March 28, 2013

Re: Dufferin Wind Power Inc. - Application for Leave to Construct (EB-2012-0365) - Second Amendment to Application and Pre-filed Evidence

## **REA Changes Report**

Renewable Energy Approval
Changes Report

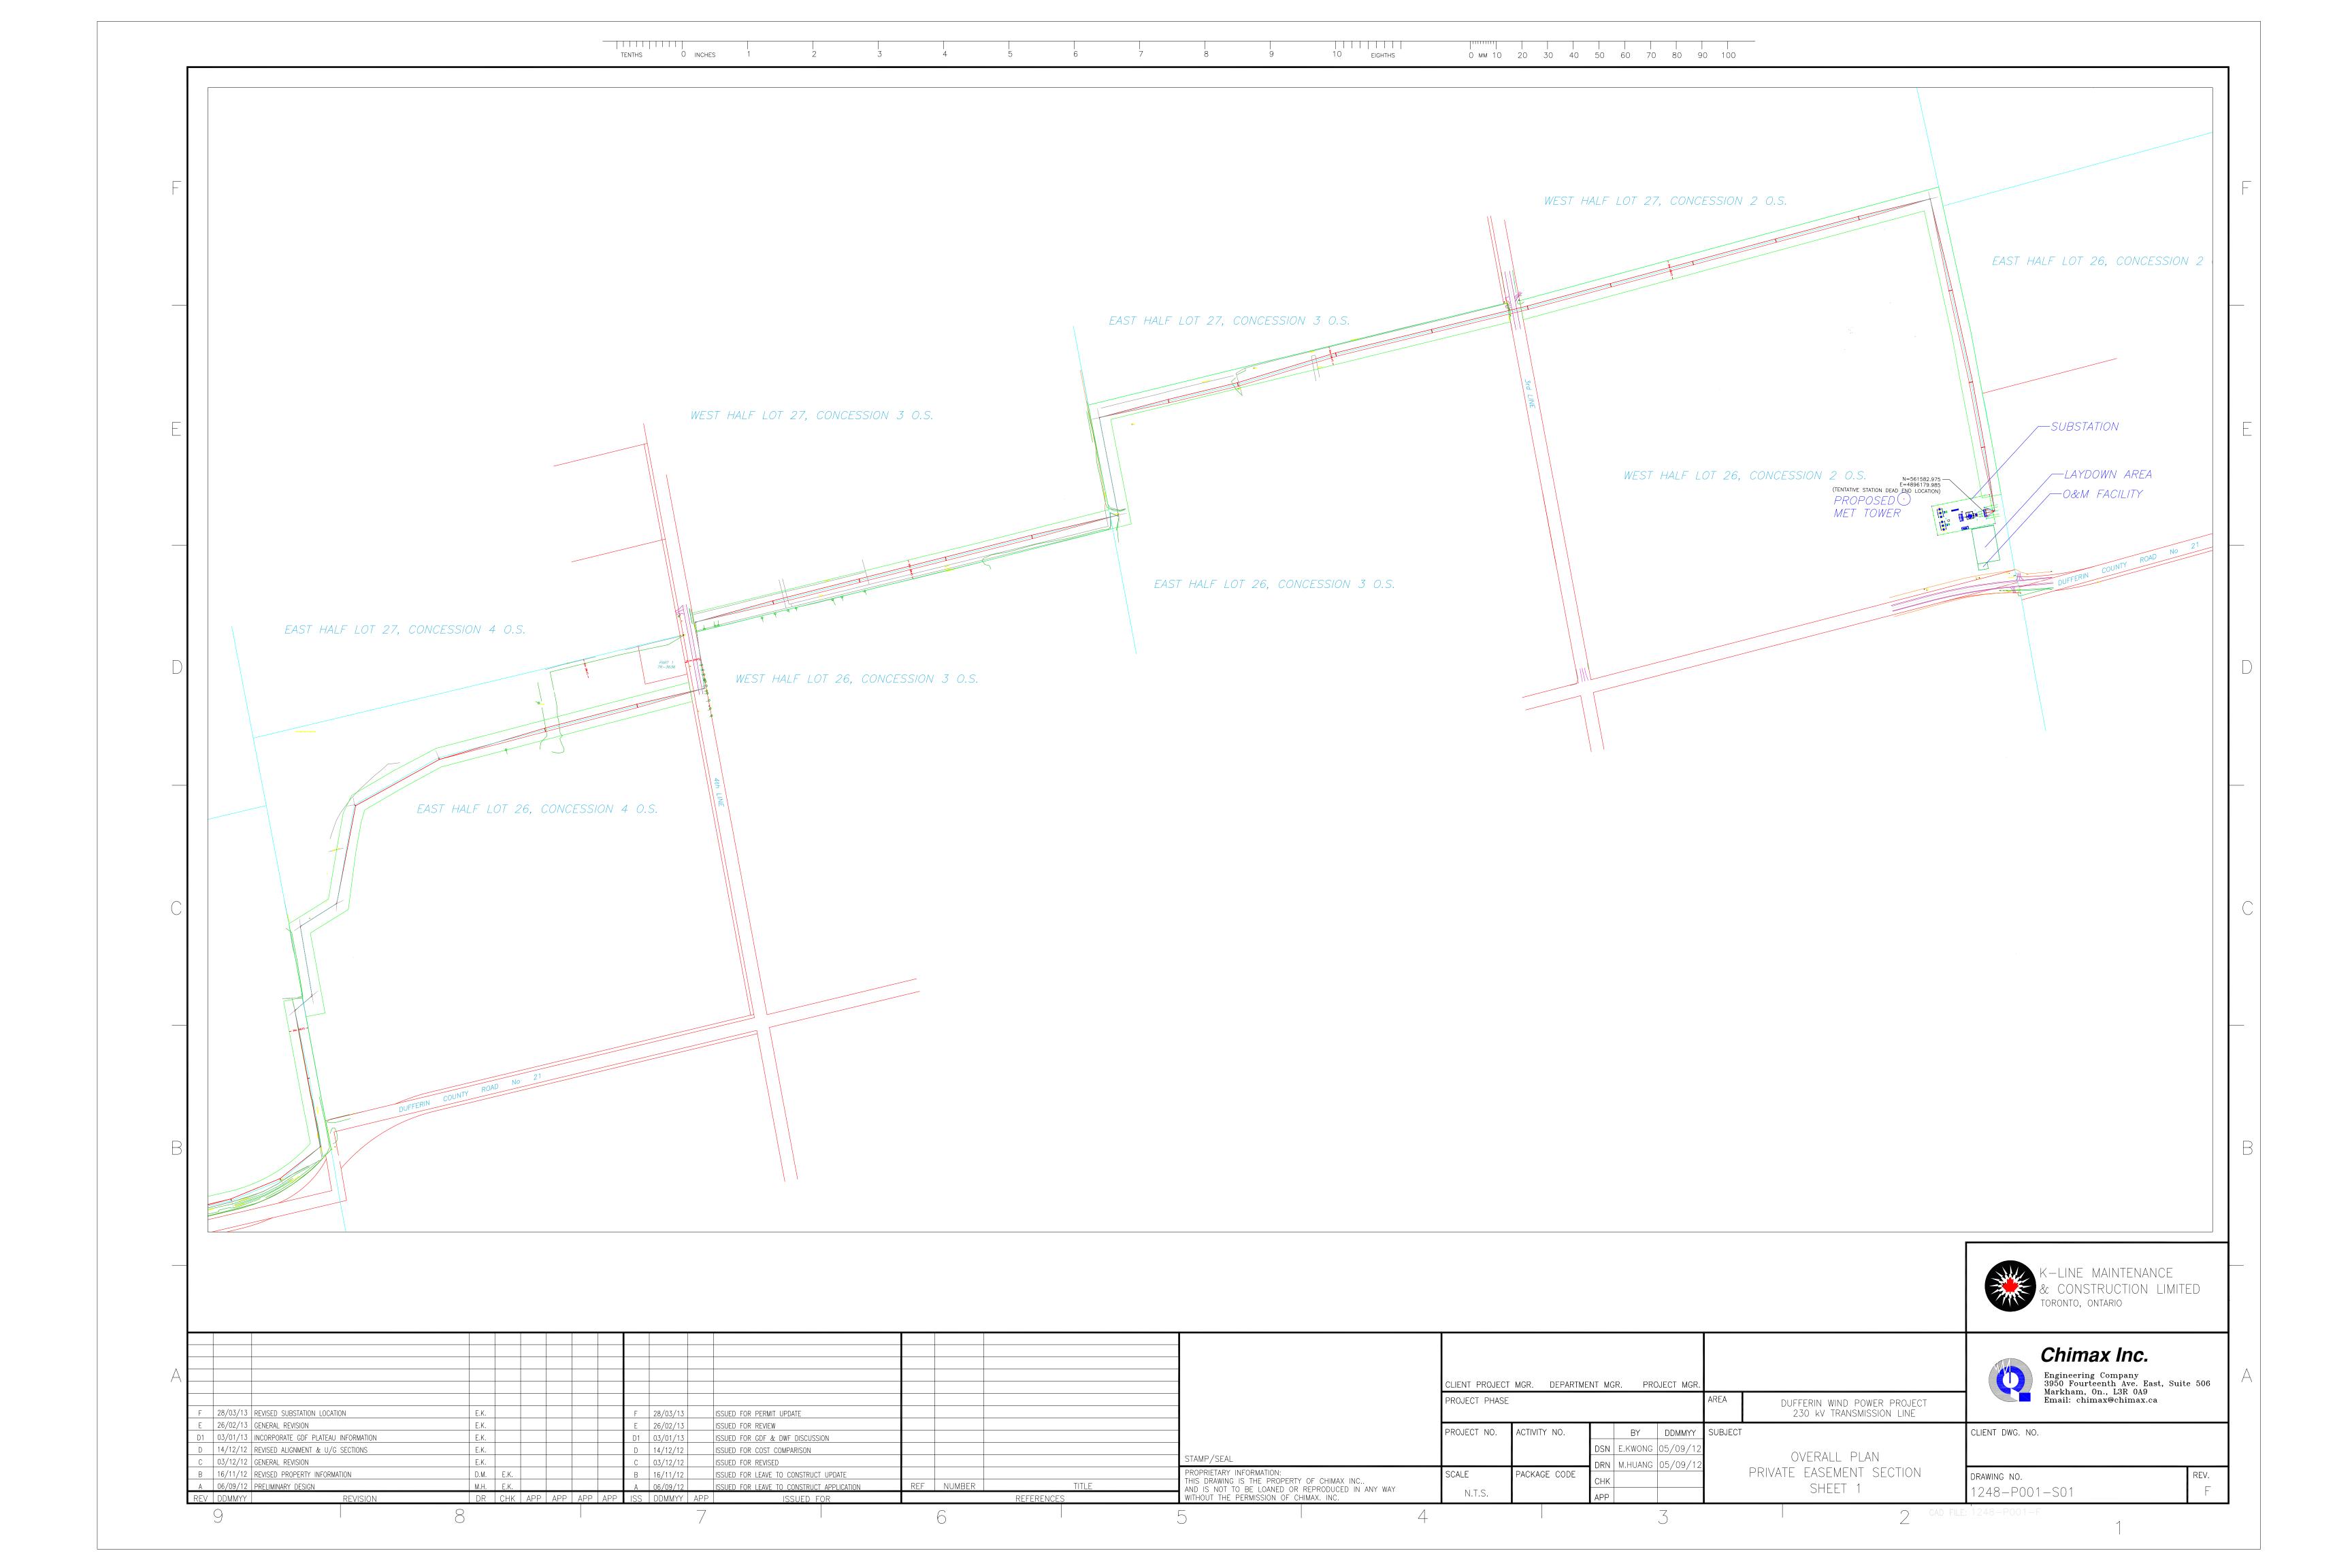
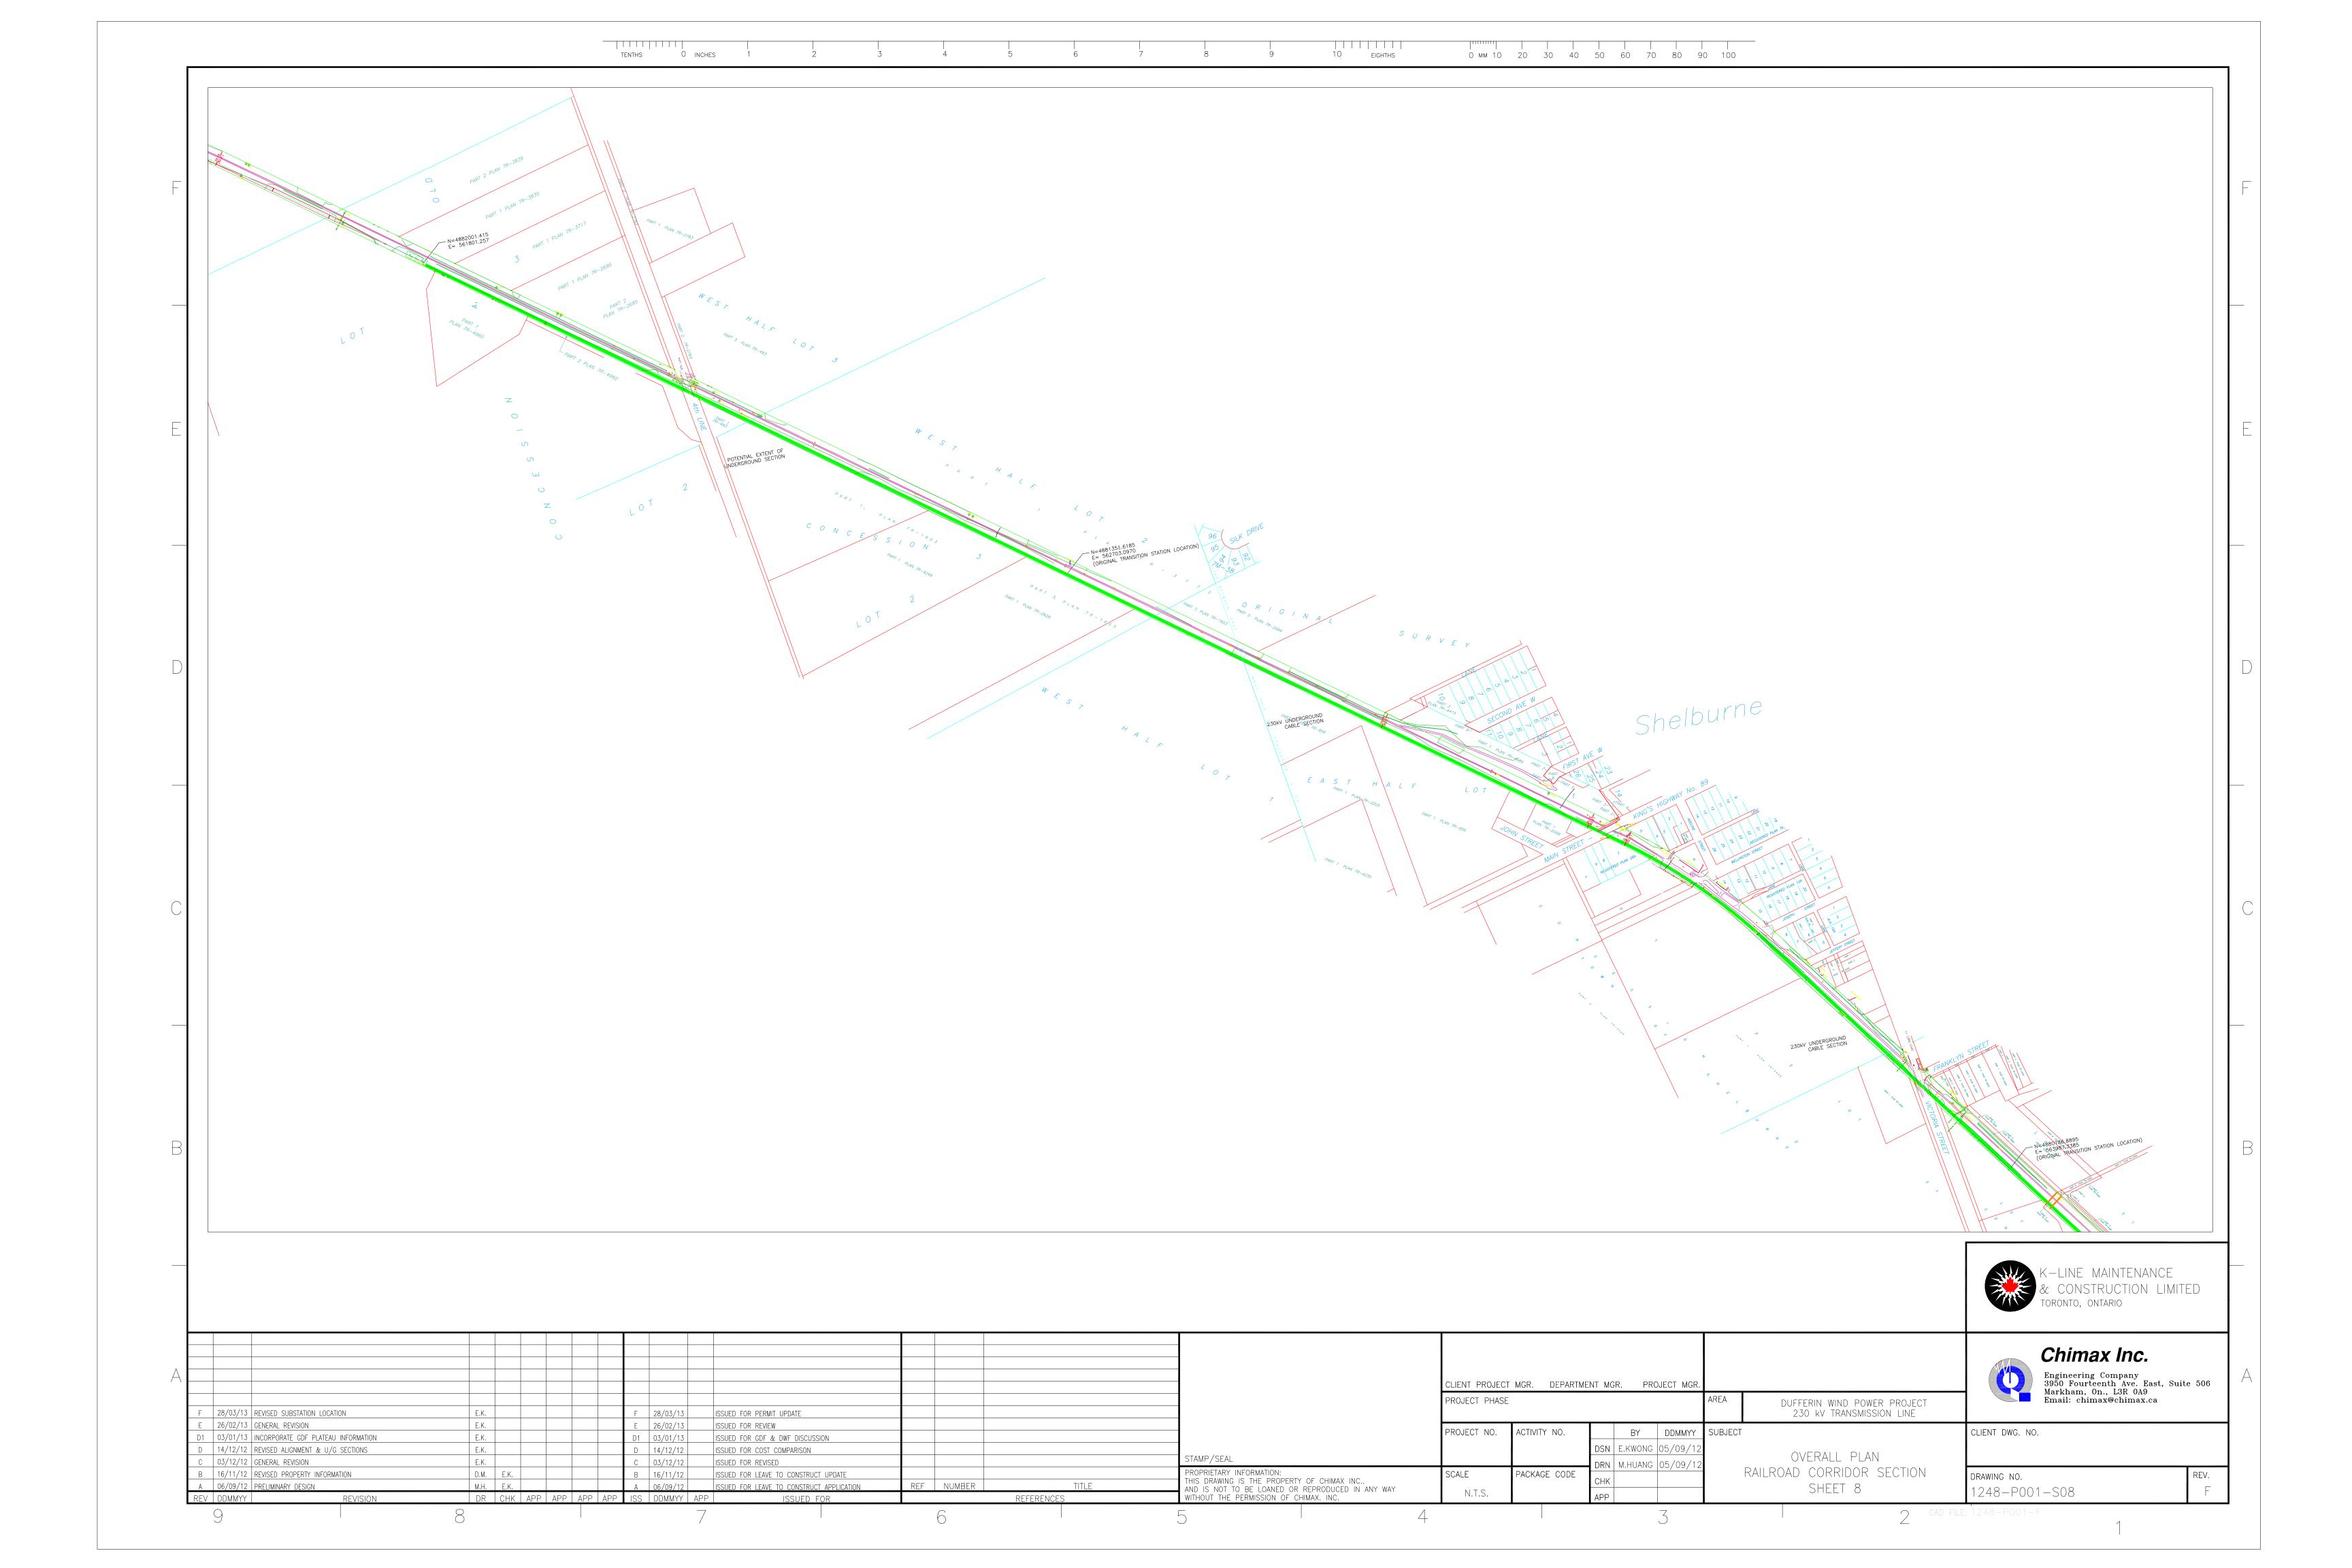
Map 5(a) in Exhibit B, Tab 2, Schedule 4 of the Application, which is marked as Drawing No. 1248-P001-S01 - Revision A, currently shows that at the point where the transmission line route reaches the west side of 4th Line it will transition from overhead to underground. The line would then cross 4th Line underground and continue running to the west underground for approximately 250 m, at which point it would transition from underground back to overhead and continue in a south-westerly direction. The thick green line on Map 5(a) depicts the approximate length of this underground segment.

DWPI amends this portion of the transmission line route. At the point where the transmission line route reaches the west side of 4th Line, rather than transitioning from overhead to underground the line would remain overhead and run south along the east side of 4th Line within the municipal road right-of-way for a length of approximately 110 m. The line would then cross over 4th Line and continue to the west until the point where it meets the transmission line route as shown in the current version of Map 5(a). An amended set of maps, including in particular a revised Map 5(a), together with blacklined pages showing corresponding changes to the pre-filed evidence and certain interrogatory responses, is provided in Appendix 'B'.
